MISSISSIPPI POWER & LIGHT COMPANY

SUBJECT: Grand Gulf Nuclear Station
Units 1 and 2
Docket Nos. 50-416 and 50-417
File 0260/L-380.0/L-371.0
NRC/INEL Audit Action Items
AECM-81/30

NRC/INEL STRUCTURAL AUDIT

AUDIT ACTION ITEMS

RODOFOAM II COMPRESSION DEFLECTION

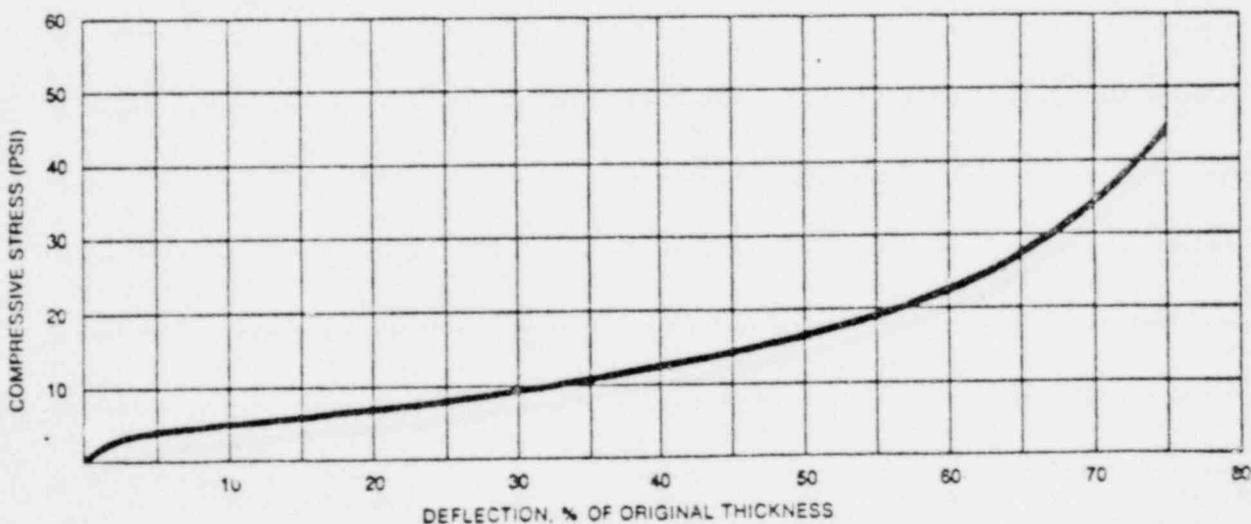
Give stiffness properties for rodofoam used between buildings.

See attached information sheets from W. R. Grace & Co. for Rodofoam.

Under seismic testing, load transfer at 50% compression was 17.8 psi.

At 2.8 psi lateral pressure of concrete (placed at 2 ft. vertical lift per hour at 70 F.) deflection of Rodofoam II will be 2.5%.
